6.2 Containment Systems

The information in this section of the reference ABWR DCD, including all subsections, tables, and figures, is incorporated by reference with the following departures and supplements.

STD DEP 6.2-2 (Tables 6.2-1 and 6.2-2, Figures 6.2-2, 6.2-3, 6.2-4, 6.2-5, 6.2-6a and b, 6.2-7a and b, 6.2-8a, 6.2-8b, 6.2-8c, 6.2-9, 6.2-10, 6.2-11, 6.2-12a and 6.2-12b, 6.2-13a and 6.2-13b, 6.2-14, 6.2-15, 6.2-22, 6.2-23a, 6.2-23b, 6.2-24, 6.2-25a, and 6.2-25b.)

Figure 6.2-12a Drywell Pressure Time History for MSLB

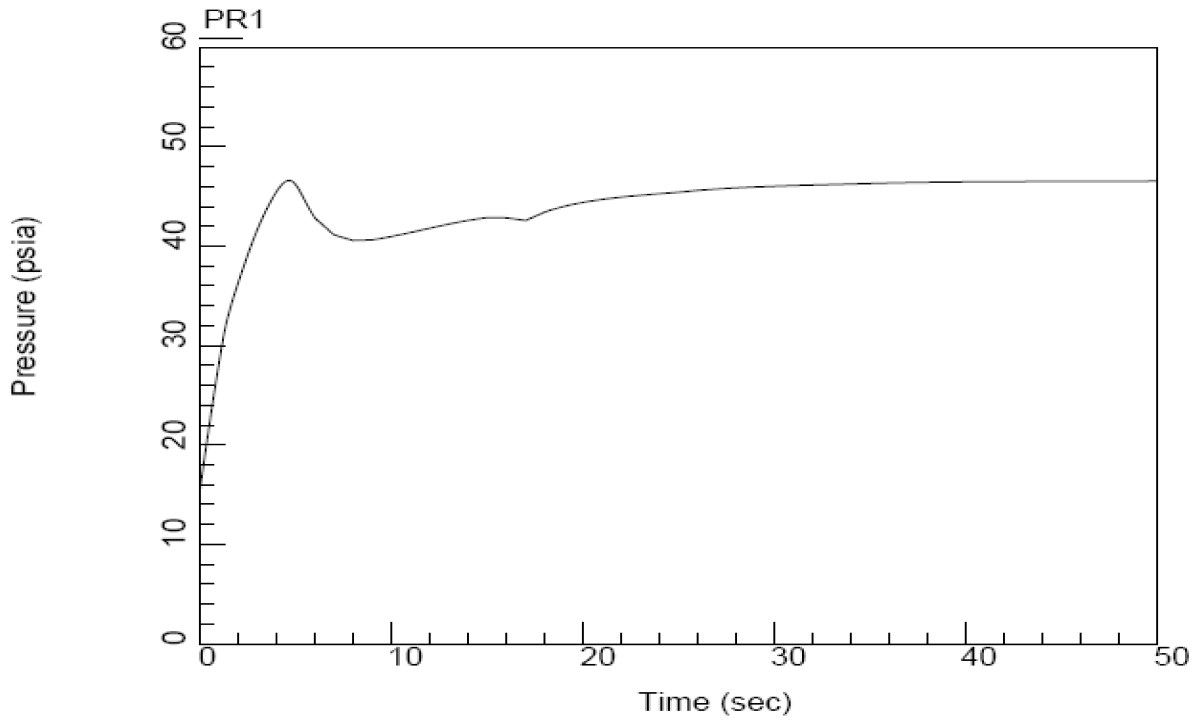
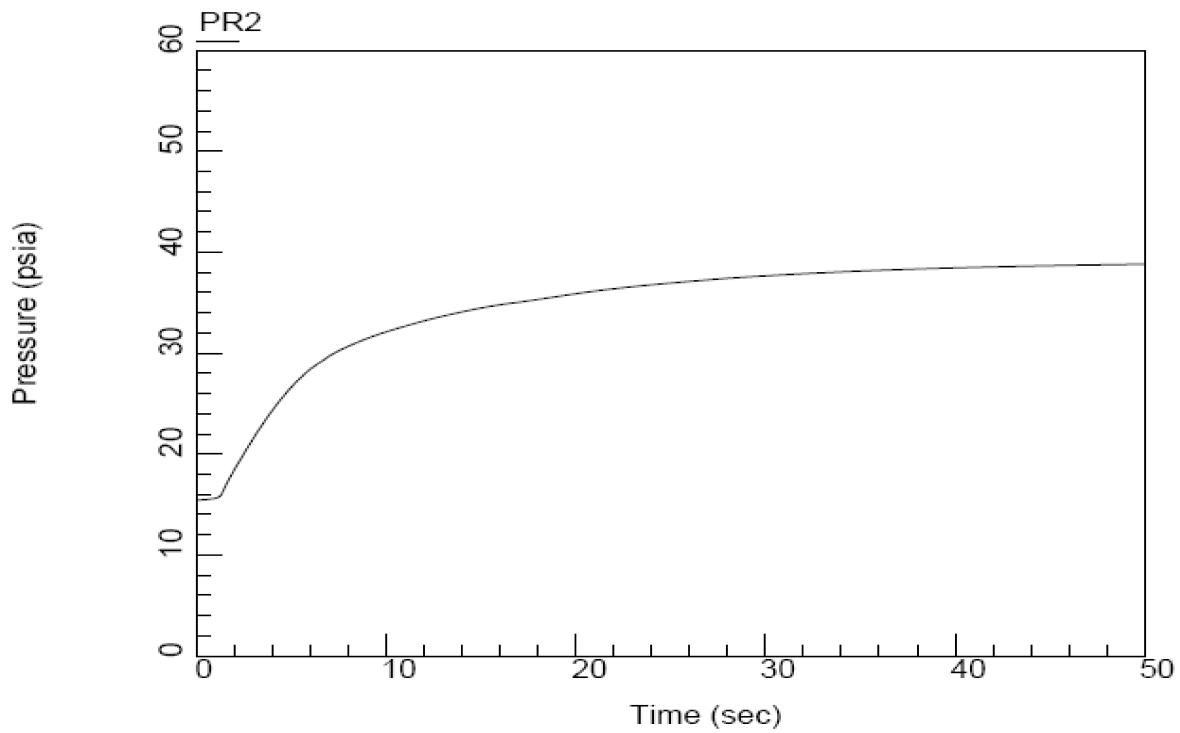
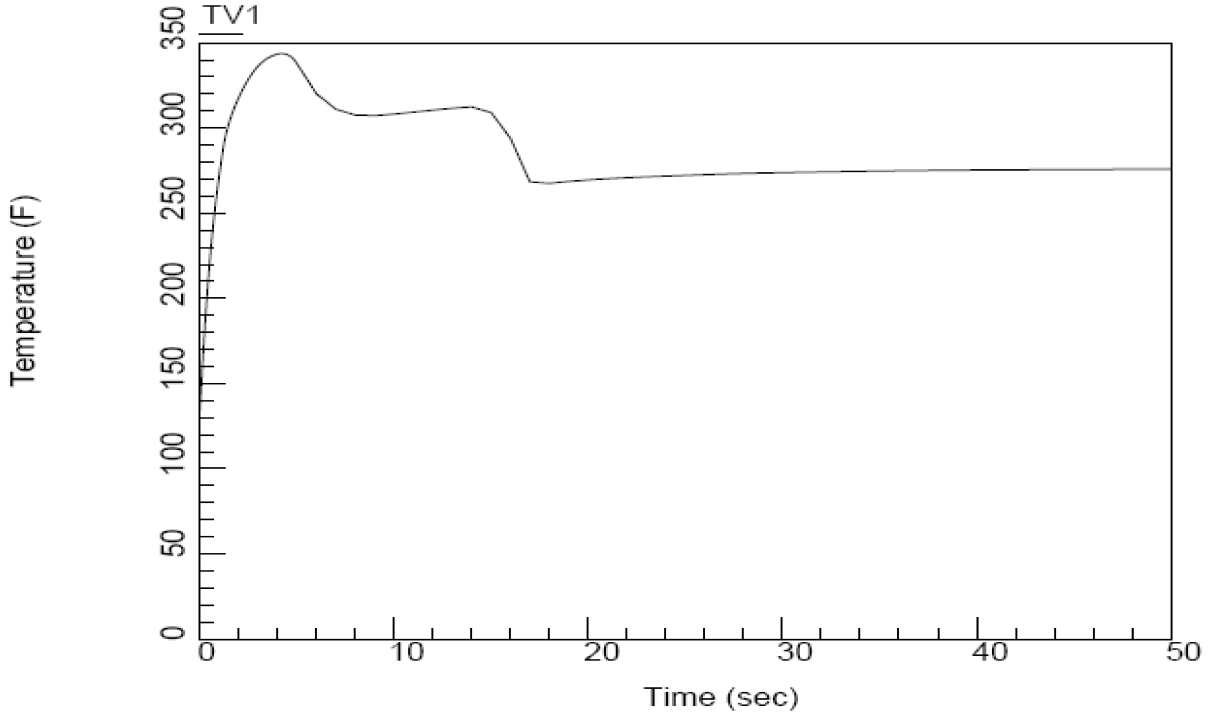
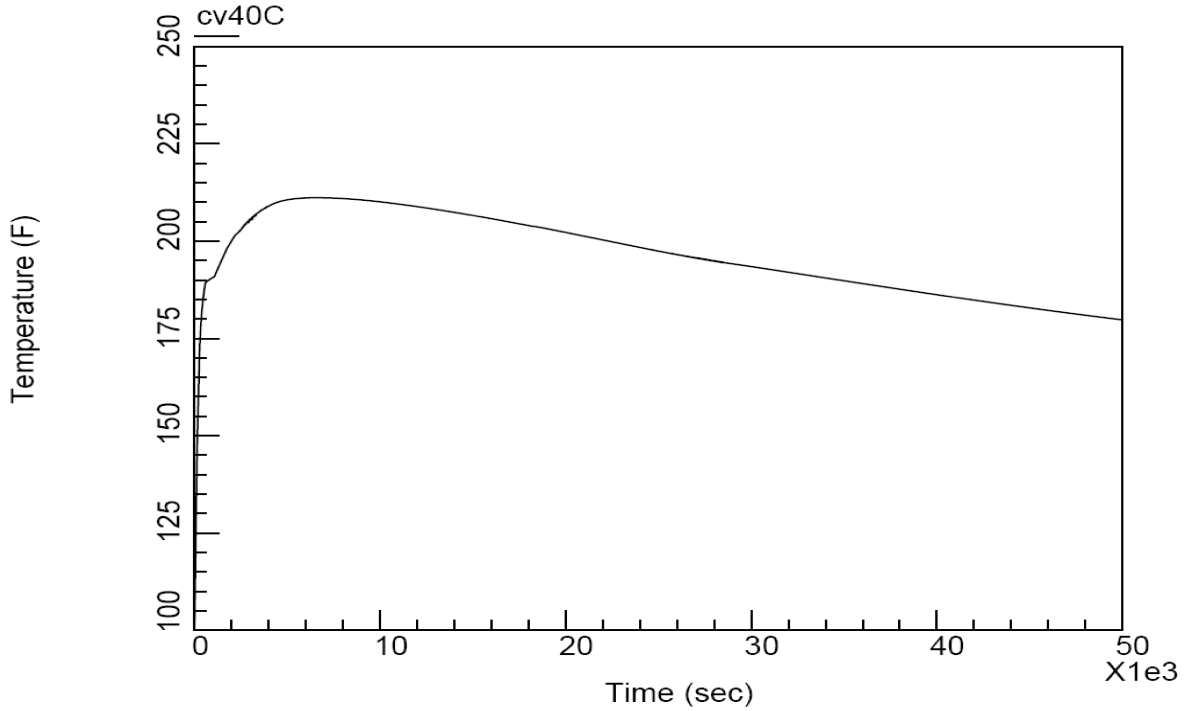
*Figures 6.2-12 ~~through 6.2-15~~*and 6.2-13 *show the pressure and temperature responses of the drywell and wetwell during the blowdown phase of the steamline break ~~accident~~.*

The maximum drywell temperature (173.2°C) is predicted to occur for the steamline break. *The MSLB with two-phase blowdown starting when the RPV ~~collapsed~~*water *level is at* or below *the main steamline nozzle provides the highest peak drywell temperature. The peak drywell* air *temperature is ~~169.7~~*173.2*°C, ~~below the~~*which is above the *design value of 171.1°C, and is the limiting one as compared to the FWLB peak temperature.* As noted in Section 6.2.1.1.2.1, this peak calculated drywell temperature exceeds the design limit for only 2 seconds. *The peak drywell pressure for the MSLB remains below that for the FWLB, which becomes the most limiting.* The peak drywell temperature and pressure is below the design temperature and pressure. The MSLB is the limiting event for peak drywell temperature. The FWLB is the most limiting for drywell pressure.

~~*The long-term containment pressure and temperature responses following the MSLB accident remain below those for the feedwater line break, which is the most limiting event.*~~The long-term containment pressure response following the MSLB accident remains below that for the feedwater line break. The long-term temperature response remains below that for the peak achieved in the short term for the steam line break shown in Figure 6.2-13.
